**ERCOUPE
SERVICE
MEMORANDUM**

No. 28

**SUBJECT: Engine Crankshaft
Affect of change**

**SUBJECT: Interchangeability of Propellers for the A65, C75, and C85 Continental
Engines.**

CROSS-SECTION OF
WOODEN PROPELLER HUB

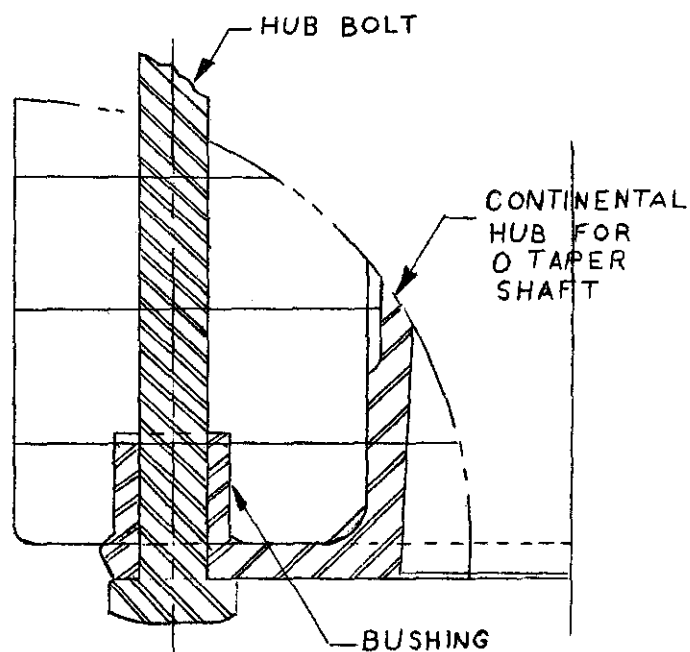
The only difference between the two is the SAE No. 1 flange requires the bolt holes be counterbored 5/8 inch diameter by 5/8 inch deep from the rear face of the propeller.

(b) The model 72C may be reworked to fit the SAE No. 1 flange provided care is exercised so that the counterbore is centered and the dimensions are as shown on the attached drawing.

The counterbore must be sealed with several coats of a high grade spar varnish and the letter K must be stamped on the side of the hub either between the letter C and the pitch designation, or directly above this position.

SECTION A-A OF ASSEMBLY

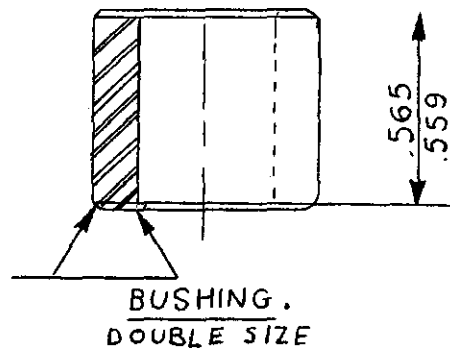
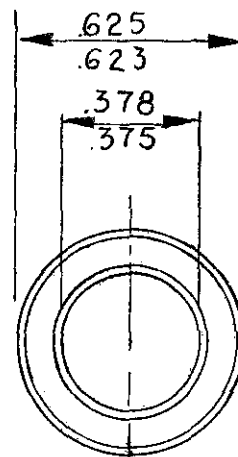
(a) The model 72CK propeller may be used on the Continental hub provided steel bushings are installed. See the attached drawing for dimensions.

02 X 45° CHAMFER
NUMBER REQUIRED: 6 PER PROPELLER
MATERIAL STEEL
